## **ADDENDUM #4**

### **PARTIAL ROOF REPLACEMENT ANSONIA HIGH SCHOOL ANSONIA, CT**

Hibbard & Rosa Architects, L.L.C.  
Middletown, Connecticut

Date: September 17, 2025

1 ROOF PLAN  
4 ARCH. REF. : 1/A-1

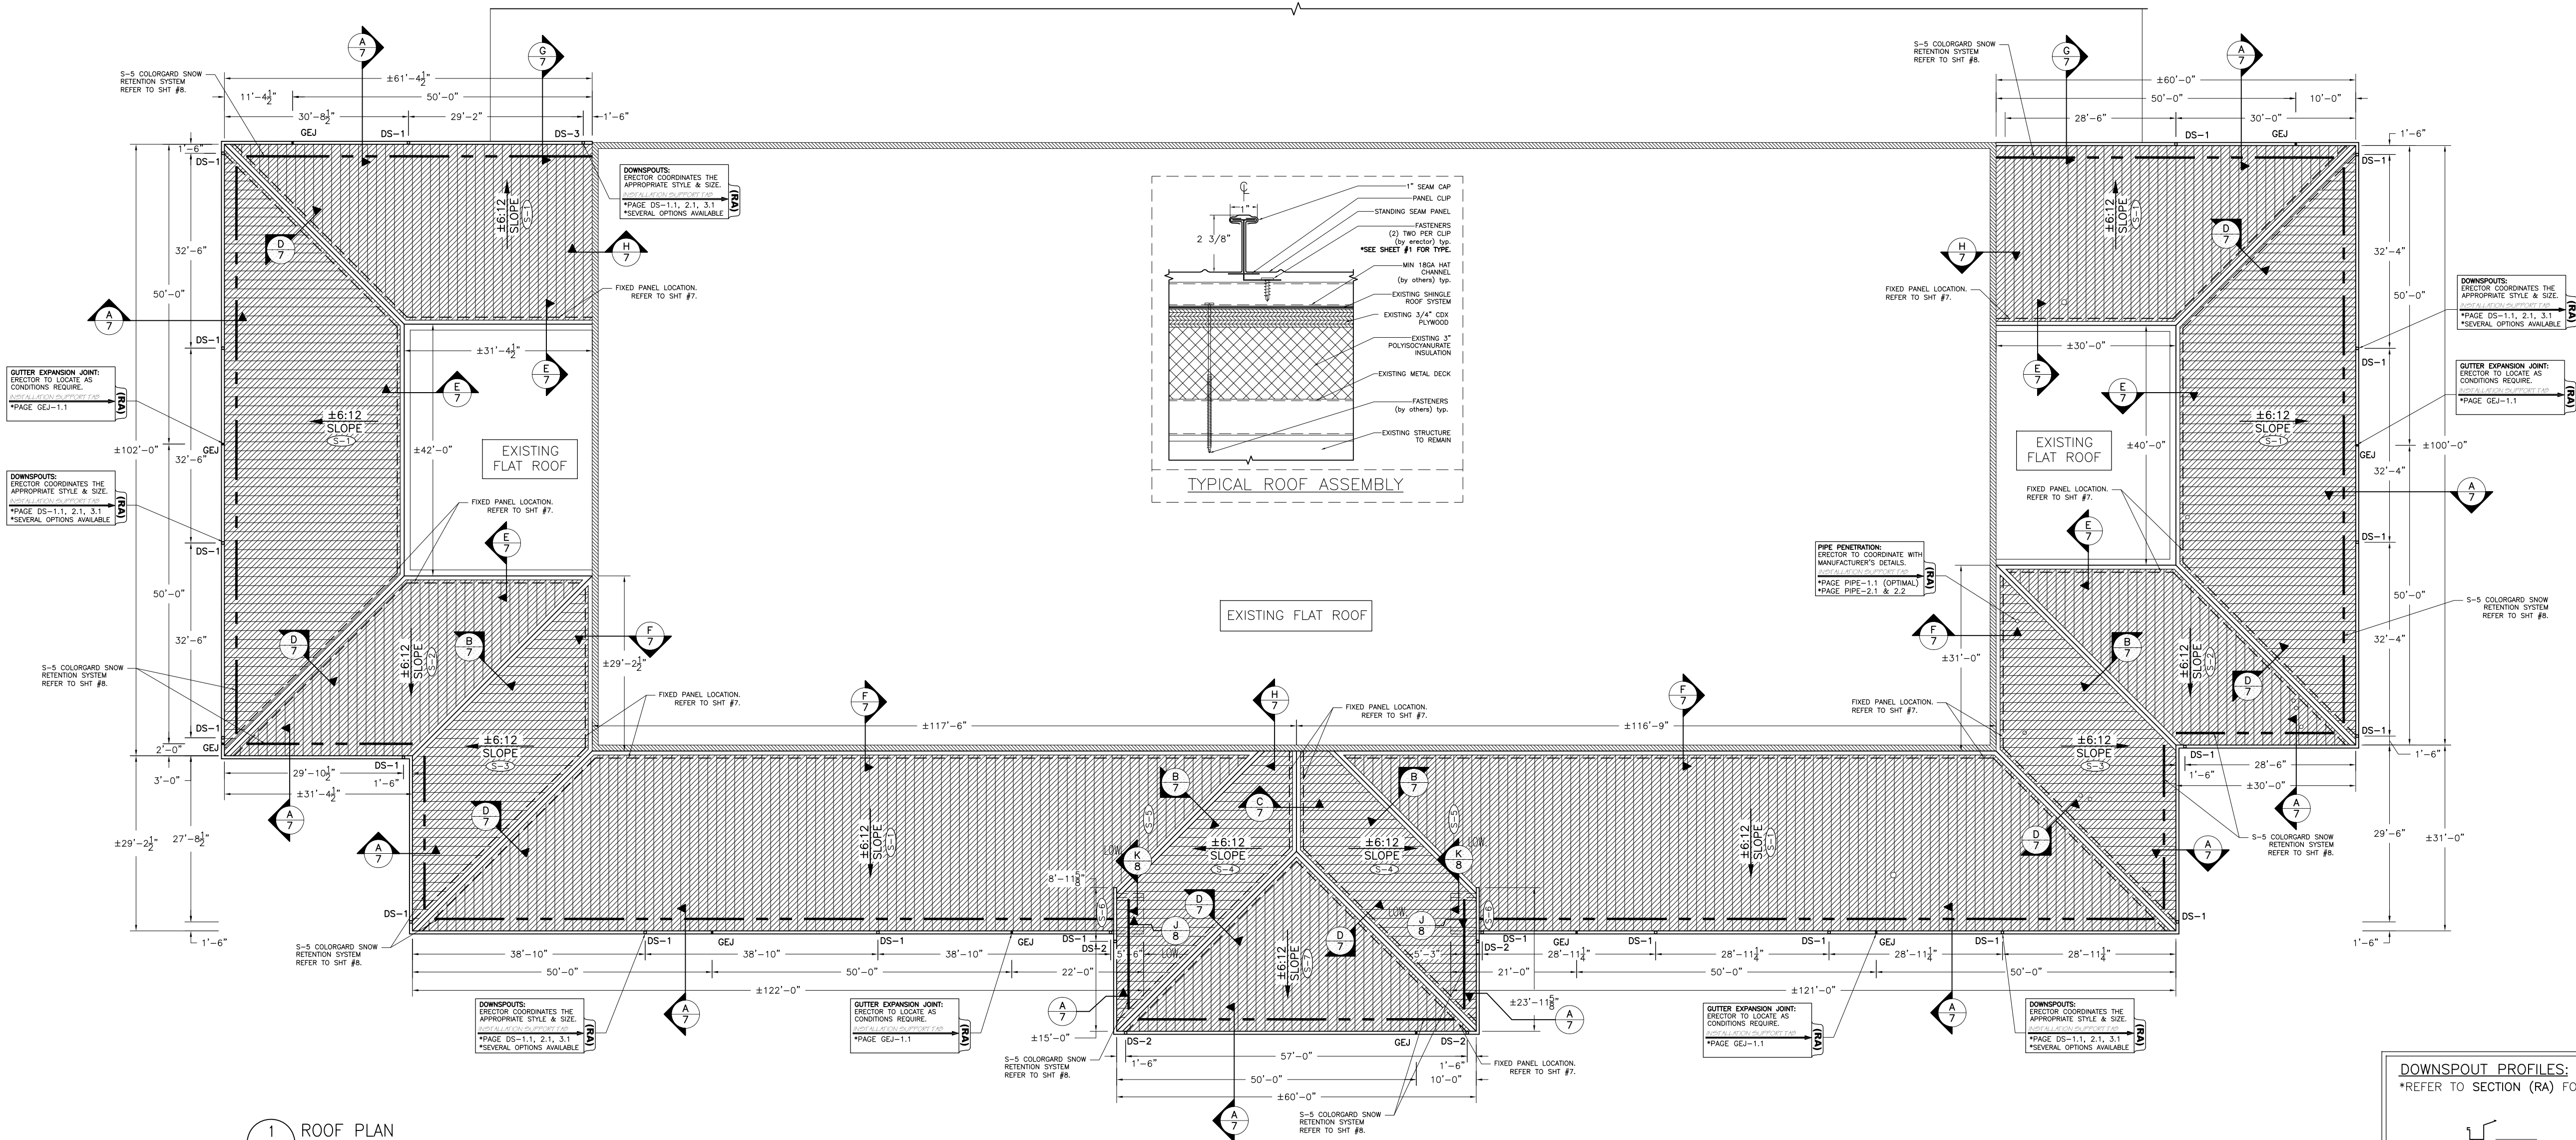
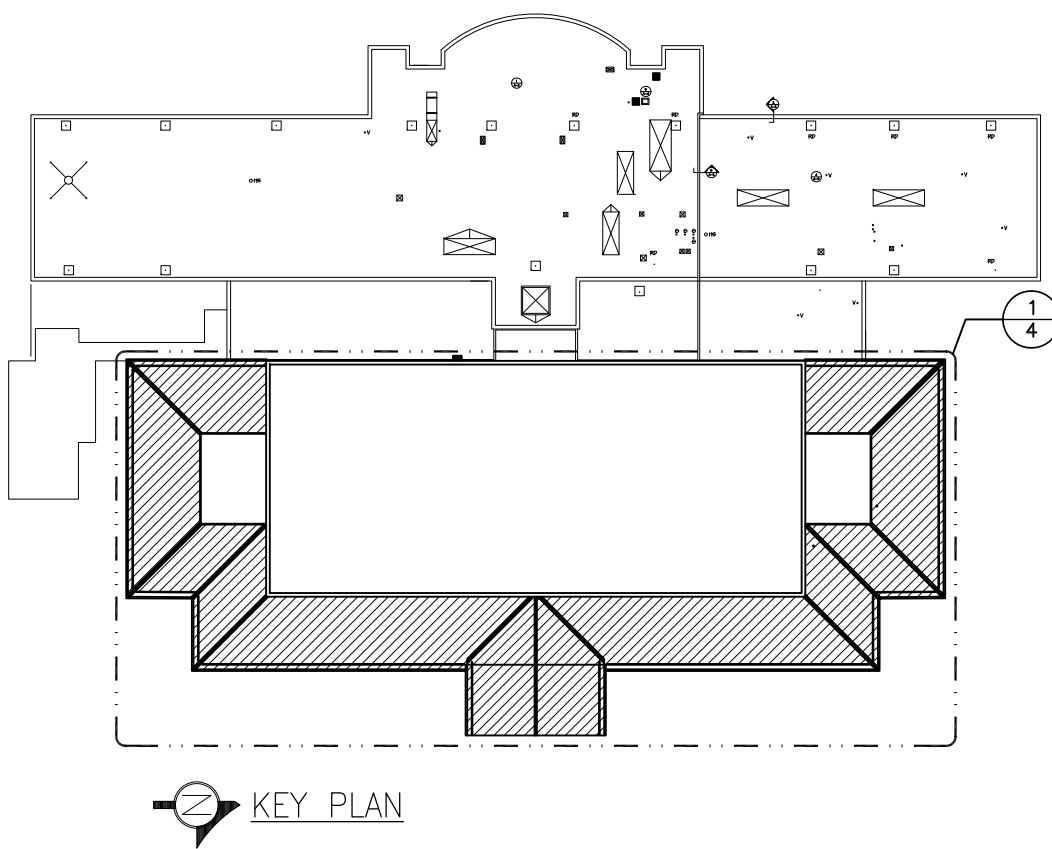
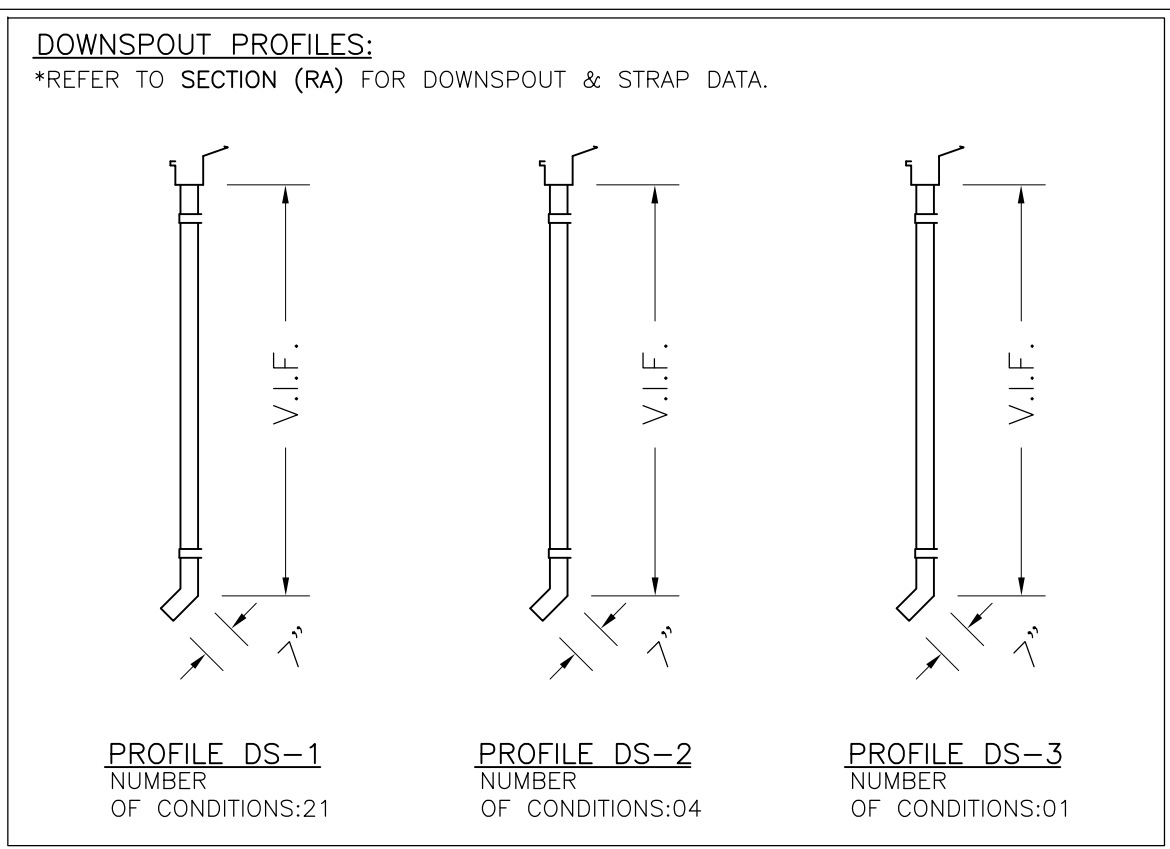
Q: We need to know the zones for the standing seam (1/2/3) to calculate how many clips to carry.

Q: The drawings do not show where the downspouts and gutter expansion joints occur. Could you please provide revised roof plan depicting the downspouts and gutter exp-j locations?

A: Please see the attached shop drawings

A: Contractor shall install 23 downspouts to align with the existing 23 downspout locations. Size to match existing. Contractor shall install 10 gutter expansion joints, final location to be determined in the field.
